INTERPRETATION APPEAL REVIEW COVERSHEET

CASE: C15-2022-0051

ADDRESS: 5900 Westminster Dr

Appeal of Site Plan Permit Case# 2020-093520 SP

PRINCIPAL ROADWAY TYPE:

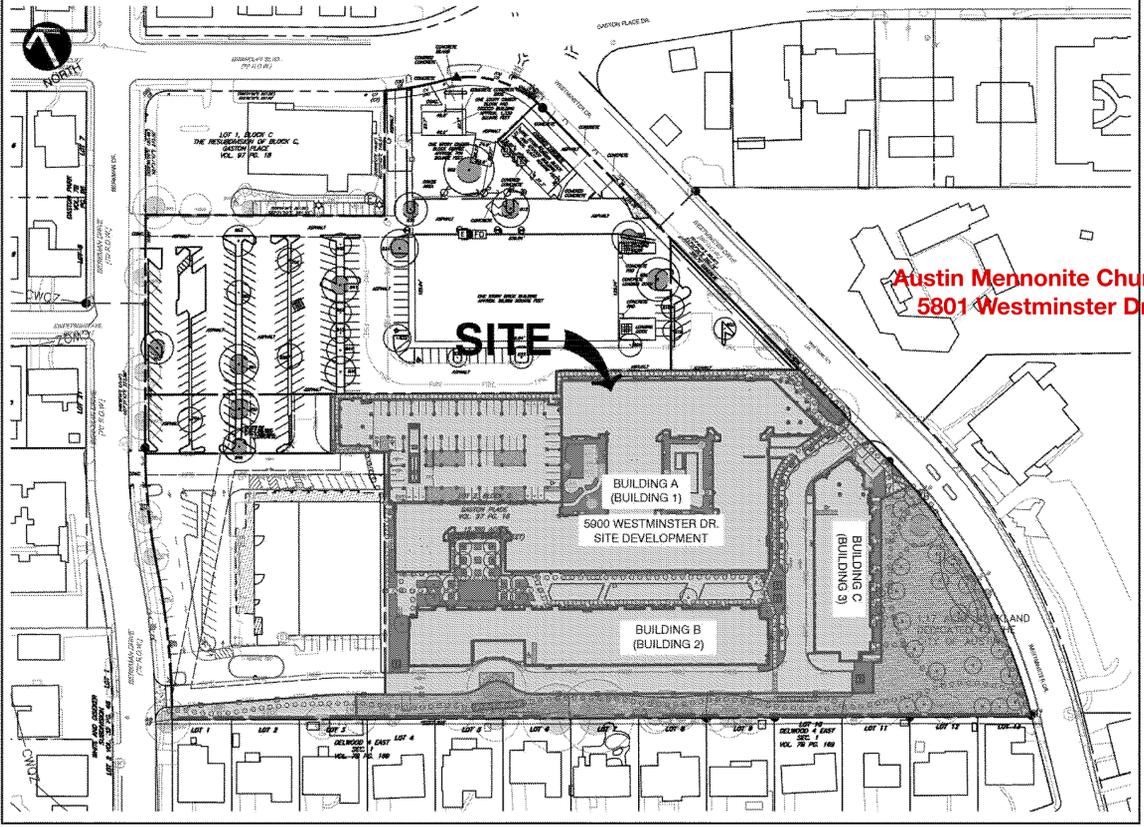
The approved Site Plan Cover Sheet C000 states that the Principal Roadway Type is Westminster Drive, which is an Urban Roadway.

- The Internal Circulation Route (ICR) is a higher street priority than an Urban Roadway. Therefore the principal street is the Internal Circulation Route. ICR in the approved site plan does not comply with requirements of a principal street for site development or VMU development.

The site plan cover page C000 includes the following Alternative Equivalent Compliance (AEC) notes:

1. Along the north-south section of the ICR, a publicly accessible sidewalk and planting zone has been provided along the entire western frontage. The east side of the ICR does not include walkways because of Building C's garage entrances. The orientation of Building C was mirrored to address community input to provide the building frontage along the public park. Mirroring Building C allowed for the implementation of desired live/work units along the park, allowed for the removal of the rear drive aisle to the garages, and thereby increased the size of the parkland dedication. The park development plans allow for north-south public pedestrian movement east of the ICR and Building C.

2. Along the west-east section of ICR, publicly accessible sidewalks and planting zones have not been provided adjacent to the ICR because of Building B's garage entrances on the north side, and because of site constructions to the south. In place of sidewalks being developed directly adjacent to the ICR, publicly accessible sidewalks have been implemented along an 8' public park trail that extends from Westminster to Berkman. The rail will be placed between existing preserved heritage trees and new plantings.

- **AEC does not propose an original or creative design, but rather explains why the applicant's site plan doesn't meet code requirements as a result of their initial design and unwillingness to consider revisions or look at Windsor Village as a whole.**

- **An AEC was suggested by the City and was considered and incorporated in the final plan update. There is no documentation on file of AEC being approved in writing.**

DRAWING NO: **C200**

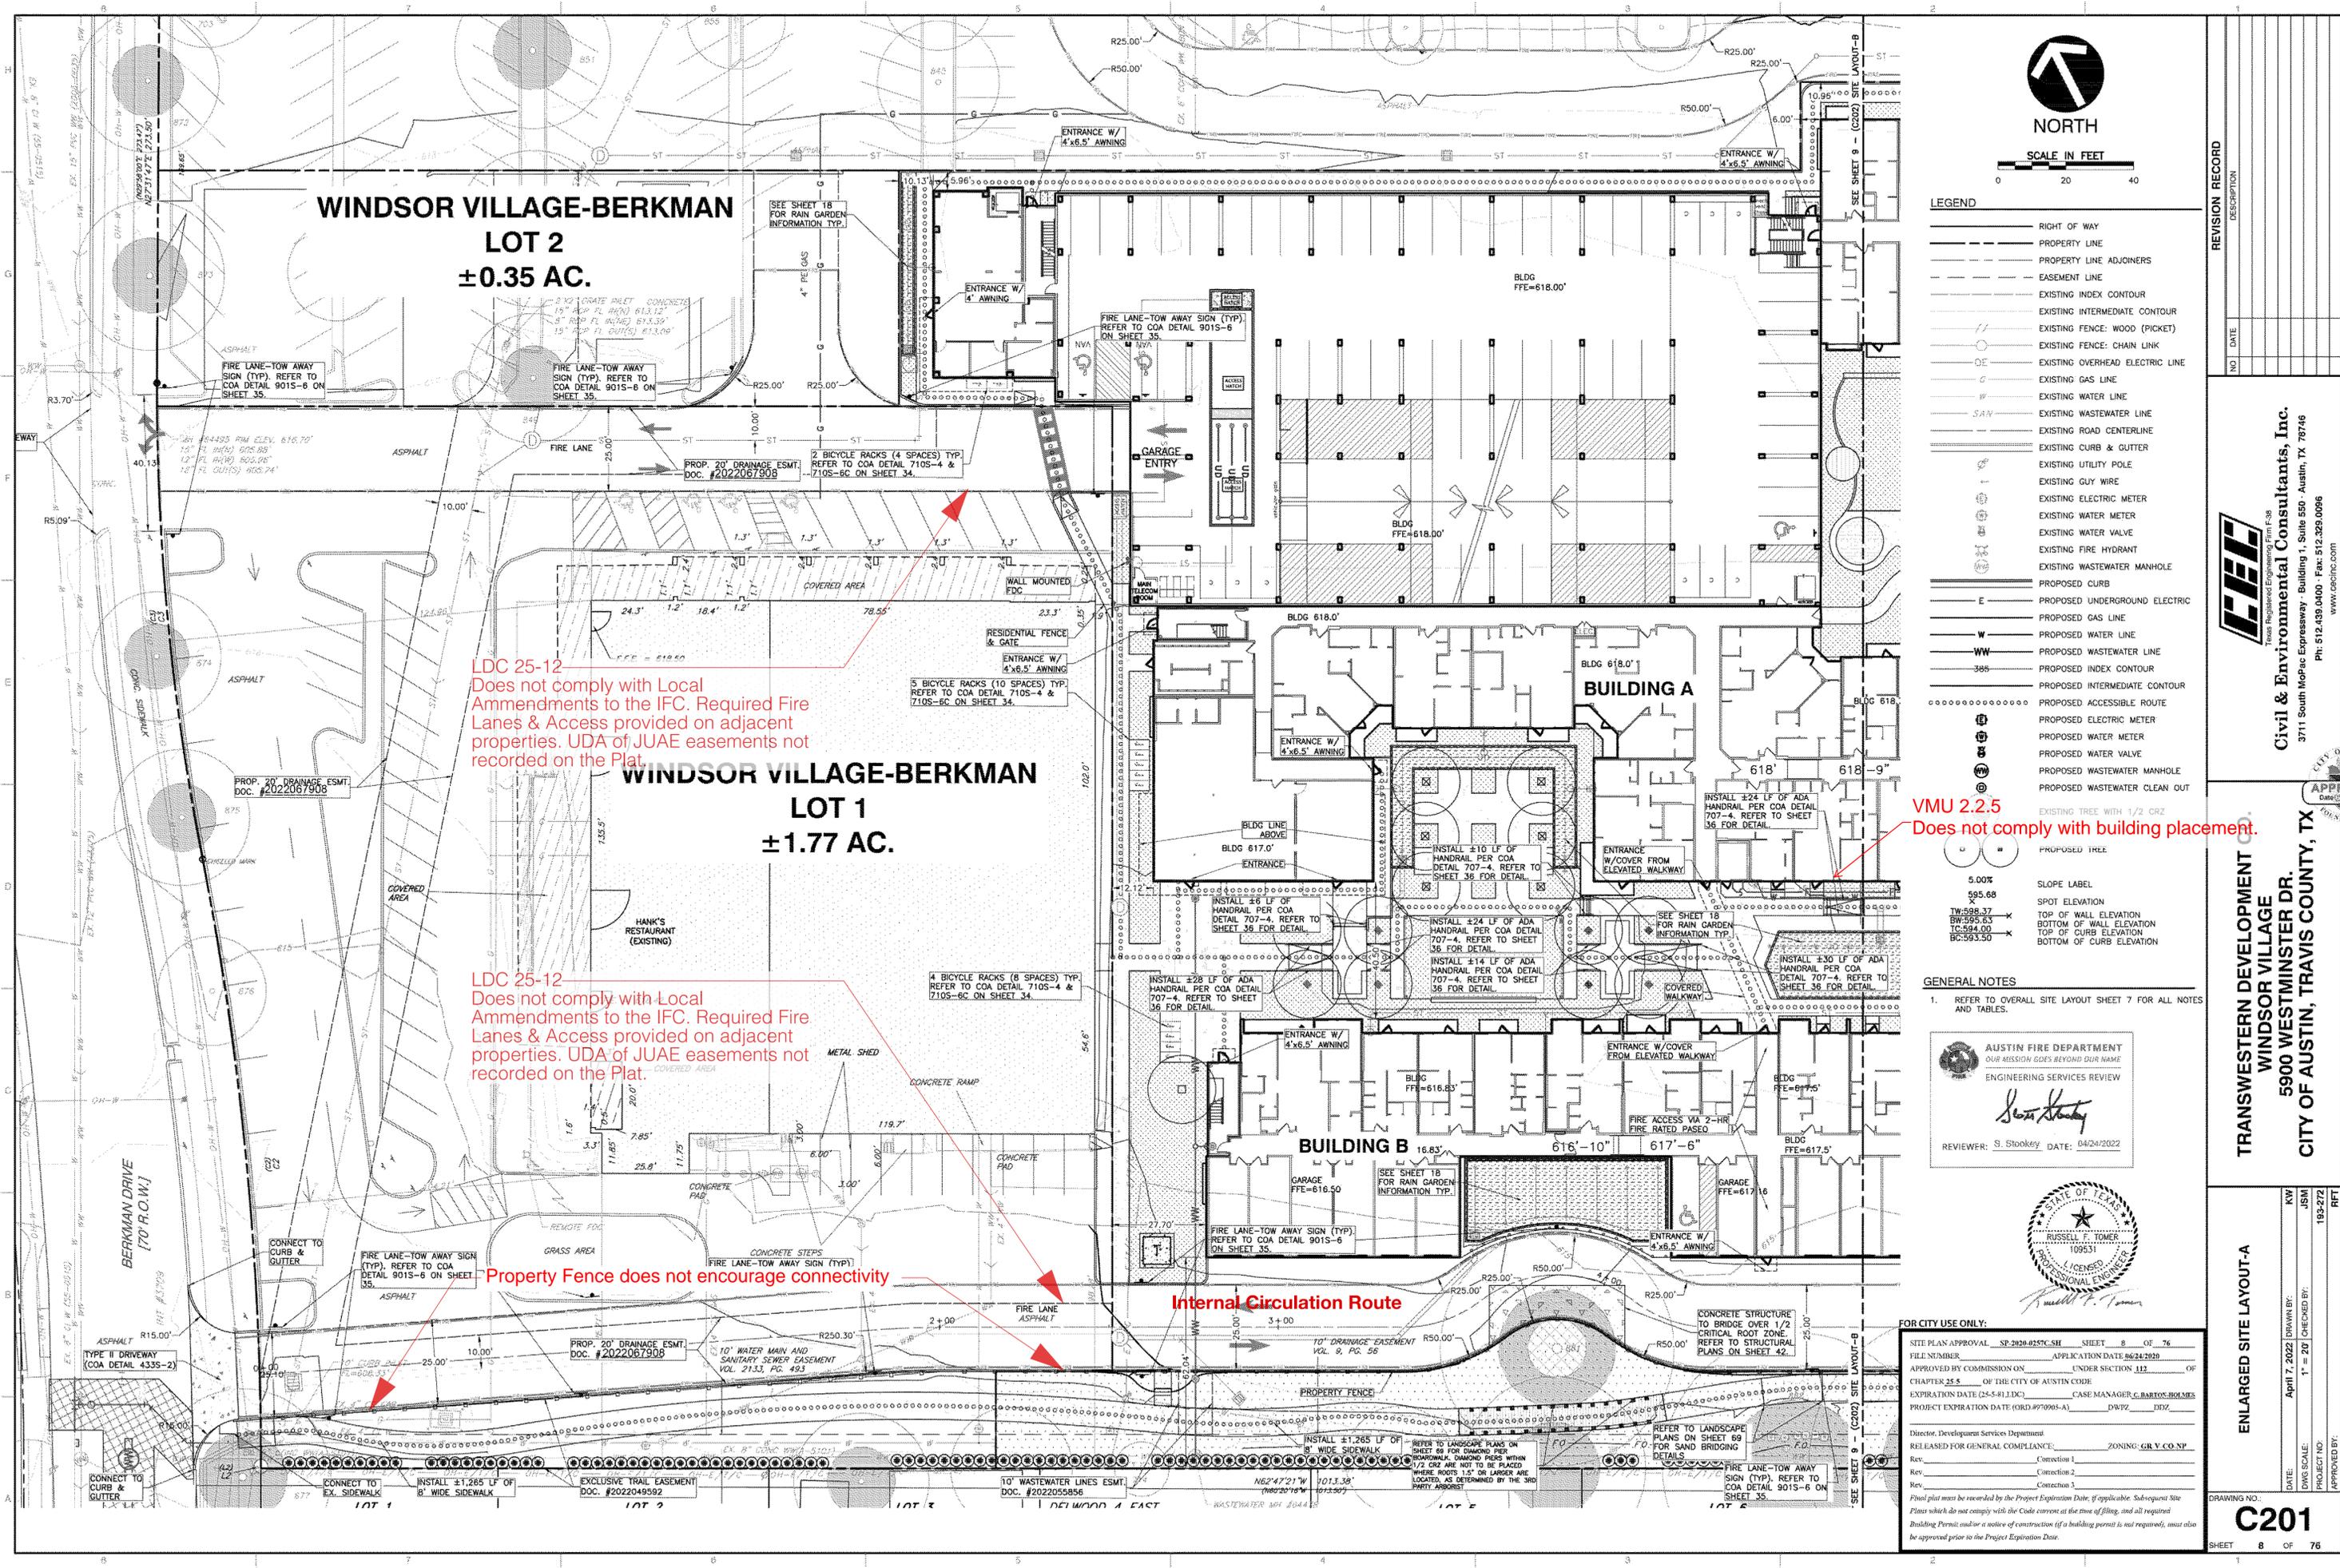
- The Windsor Village Development is 5 acres, designed with the principal street frontage on an Urban Roadway (Westminster) and does not provide an Internal Circulation Route as intended and defined by the Code.
- The proposed drive does not meet the intent or definition of an Internal Circulation Route. It does not offer connectivity, is not overlooked by buildings and has no surveillance or contact from building occupants. The proposed drive is primarily lined by enclosed single-vehicle parking garages and is not grid-like.

- **The approved ICR placement yields a block area greater than 5 acres. ICR should be located to divide blocks into less than 5 acres as intended by the Code. See annotated sheet C200**

- Since the lot can be configured to include most of the proposed fire apparatus access roads, the exception for a JUAA should not be offered. The exception is not necessary and will limit future development on Lot 2. The fire apparatus access roads should be reviewed with the required Project Circulation Plan (Item III). See Annotated Sheet C200

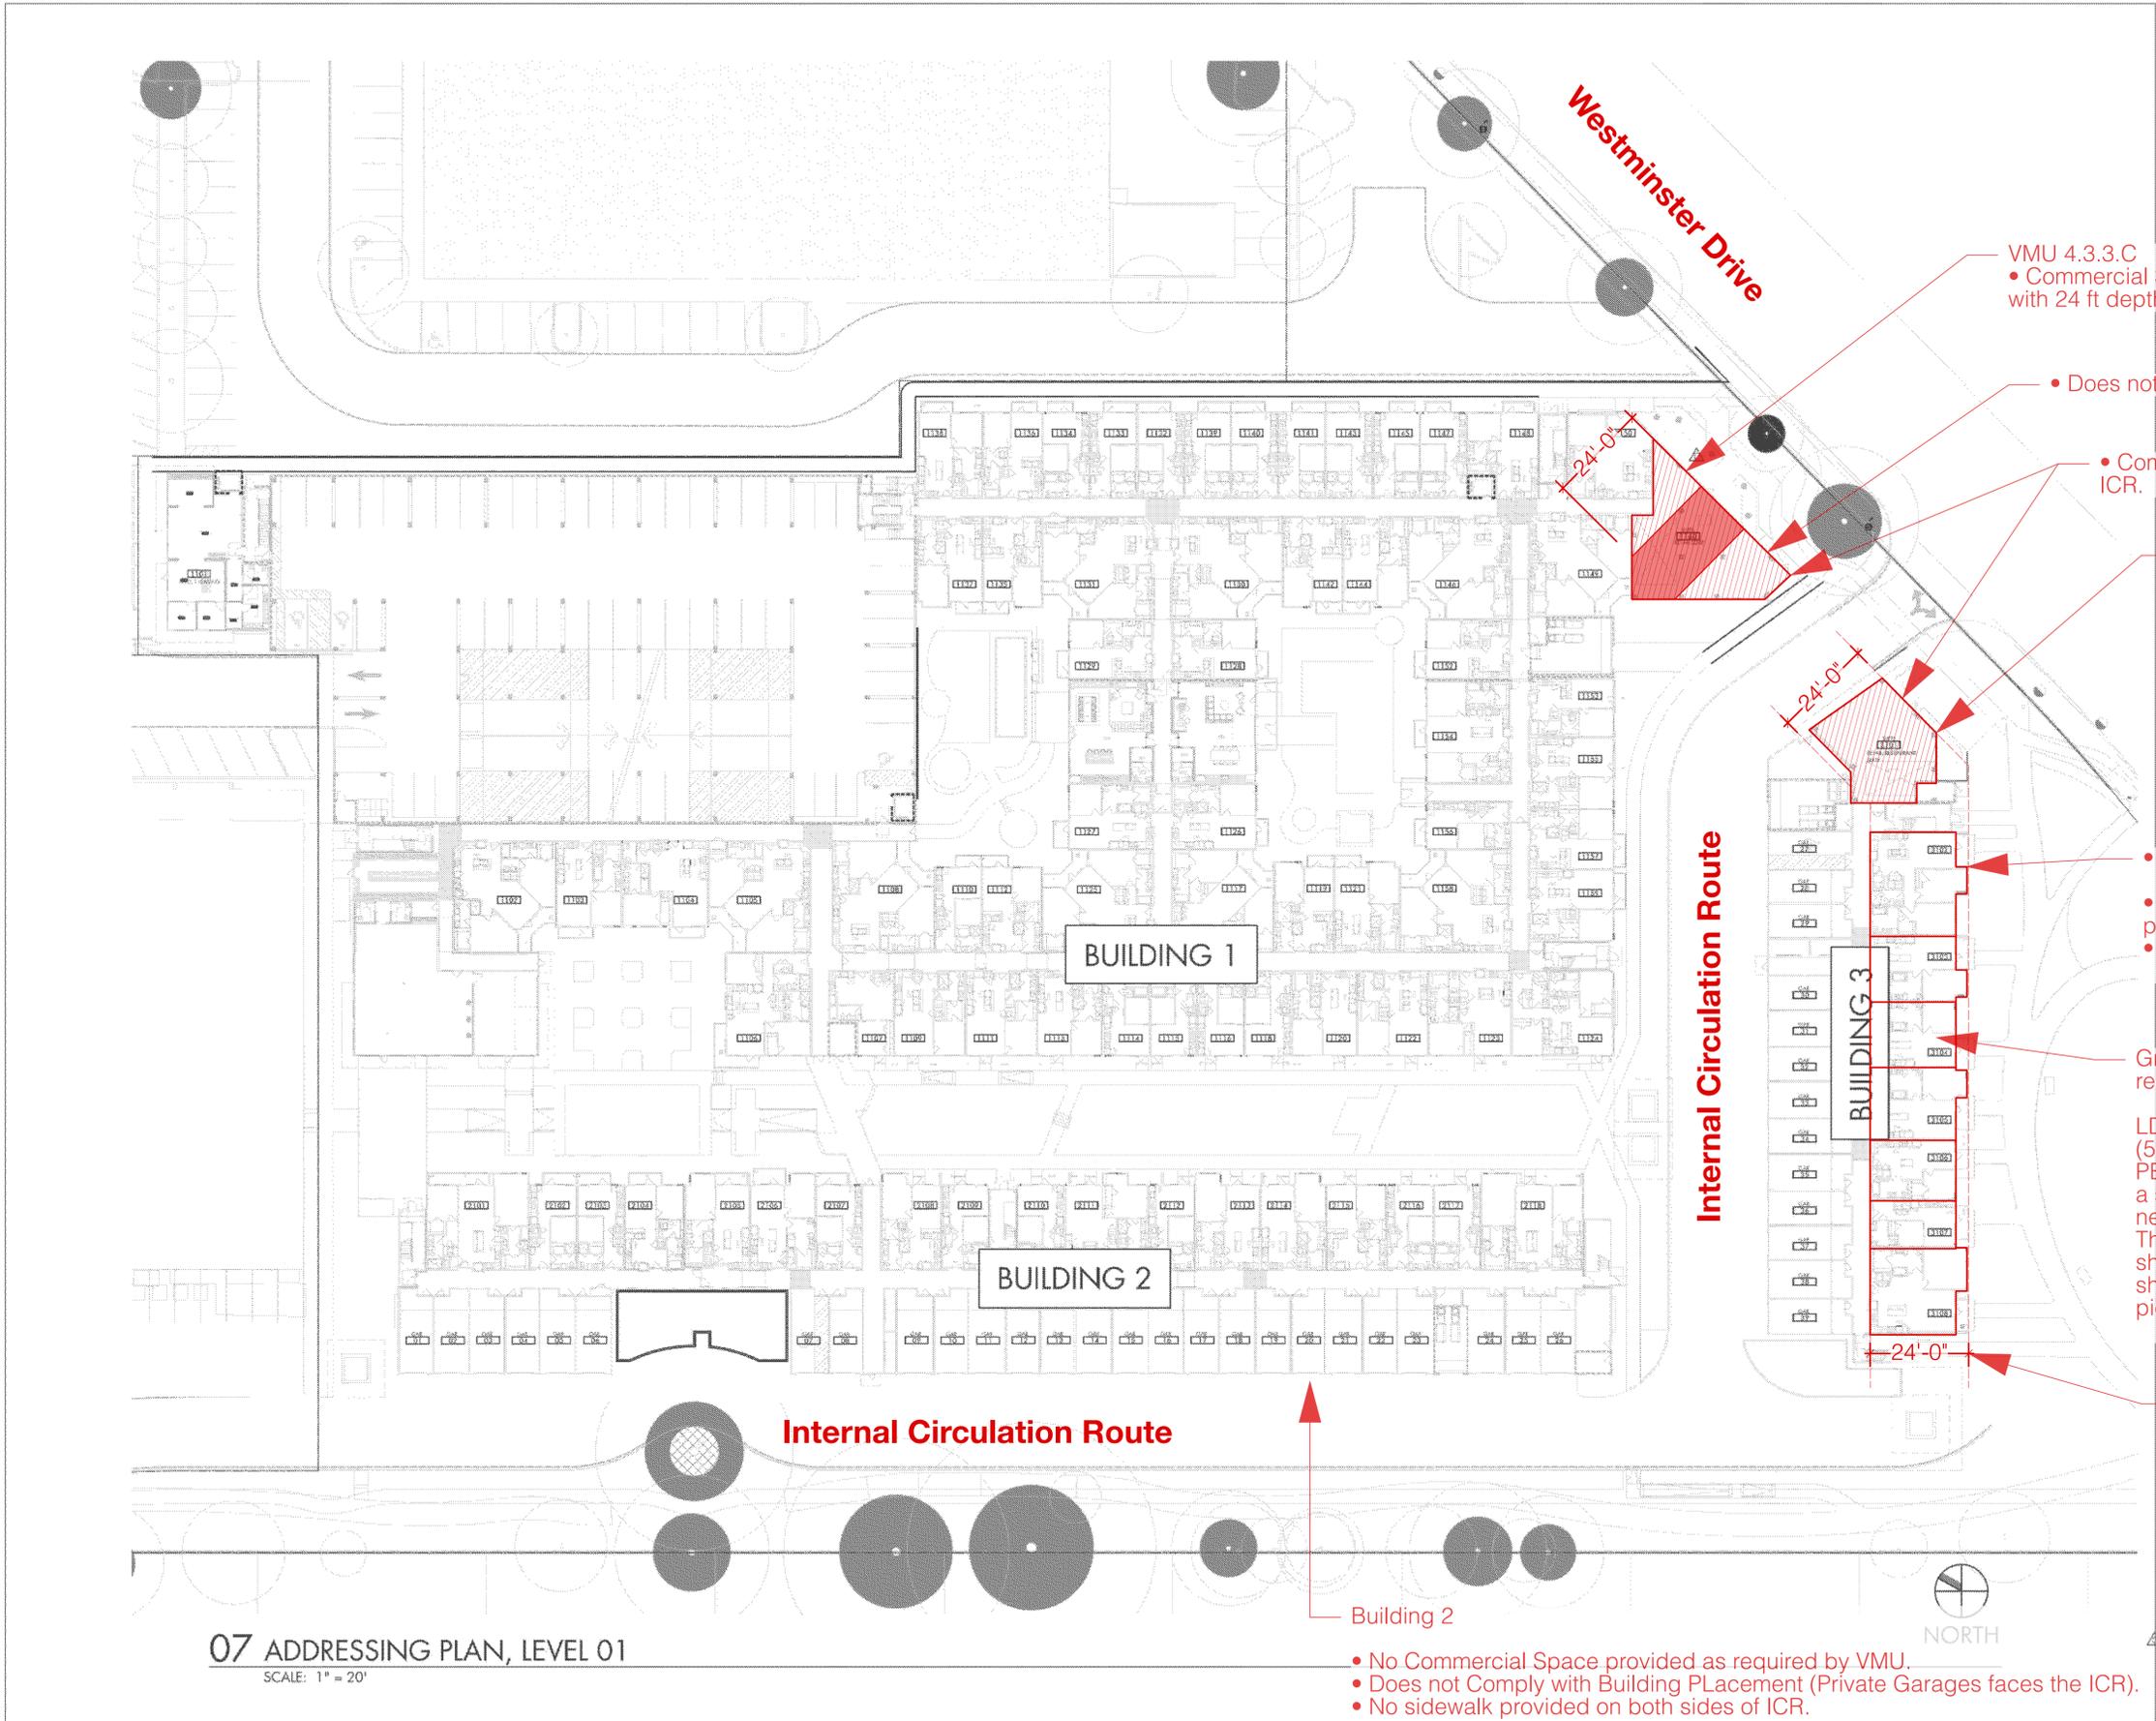
- **The development does not meet the vertical mix of uses for VMU developments.**
- **One of the three permitted buildings is 100% residential use. See annotated sheet A019**
- **Apartment units Labeled as Personal Services do not meet the Mix of uses required, See annotated sheet A019.**

- The project is enjoying undue VMU development bonuses, including reduced connectivity options requirements, relaxed impervious cover and parking reductions.
- The application of the City's interpretation and application of VMU results in a significantly smaller commercial space for Windsor Village in comparison to completed VMU developments in Austin.
- Commercial area per residential unit at Windsor Village is significantly less than completed VMU developments in Austin. See annotated sheet A019
- The Provided Commercial Space on Westminster (not the ICR/principal roadway) does not meet 4.3.3.C, 24 foot depth requirements. See annotated sheet A019

VMU 4.3.3.C
 • Commercial Space does not comply with 24 ft depth.
